Declaration Letter

Updated power board:

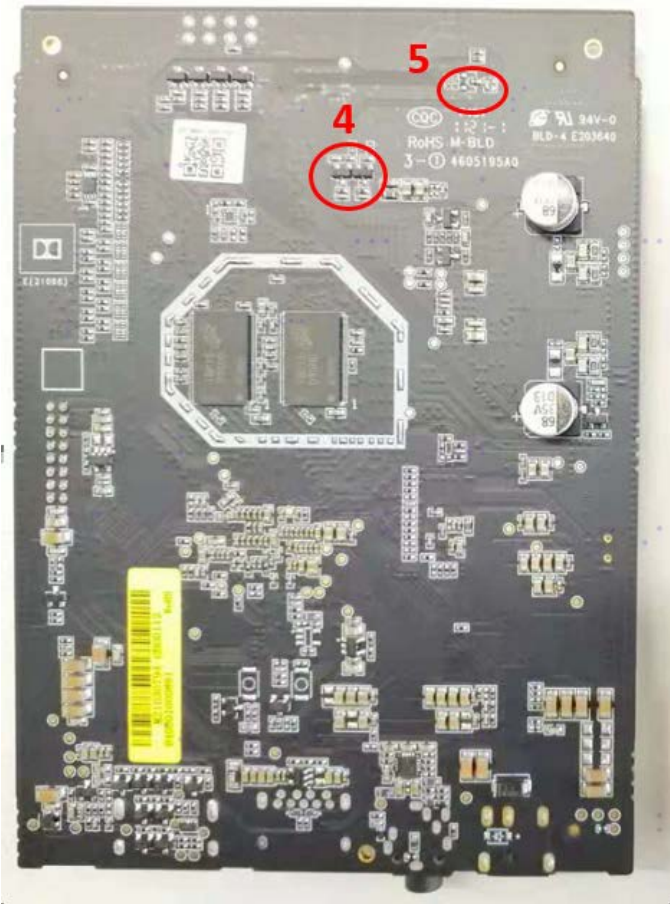
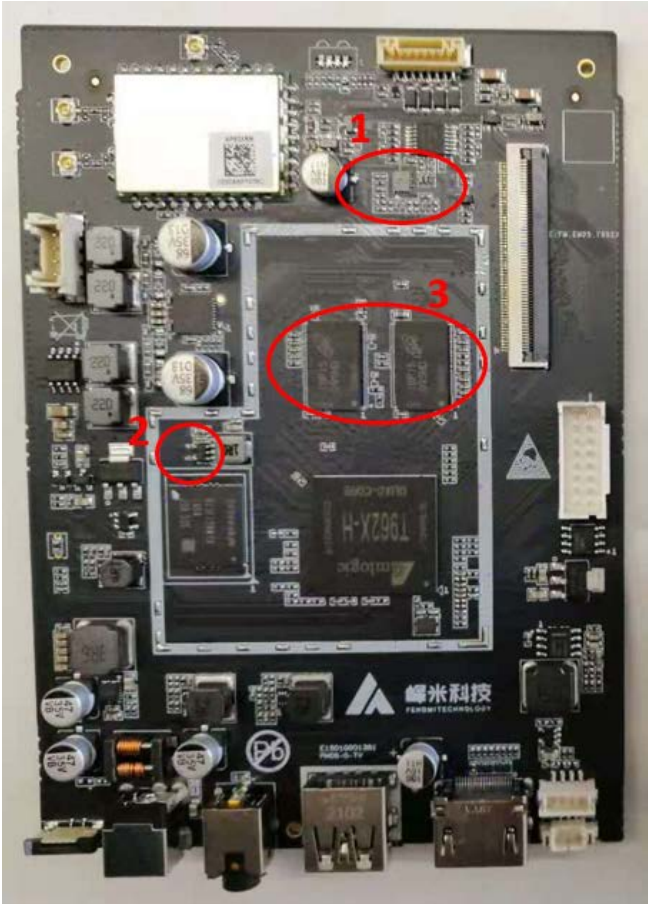
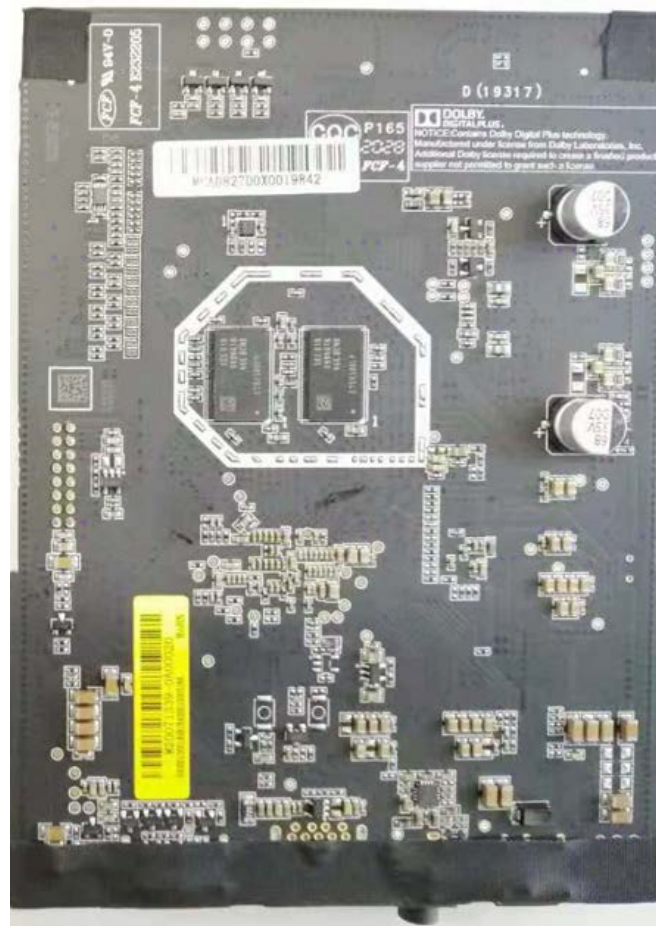
Difference items	Previous board	Updated board
Highlight 1/4/5	Updated the PCBA design for compatible with different specification Gsensor components.	
Highlight 2	Updated the PCBA design for compatible with different specification DC-DC chipset.	
Highlight 3	MICRON Brand DDR replace of the Samsung Brand DDR.
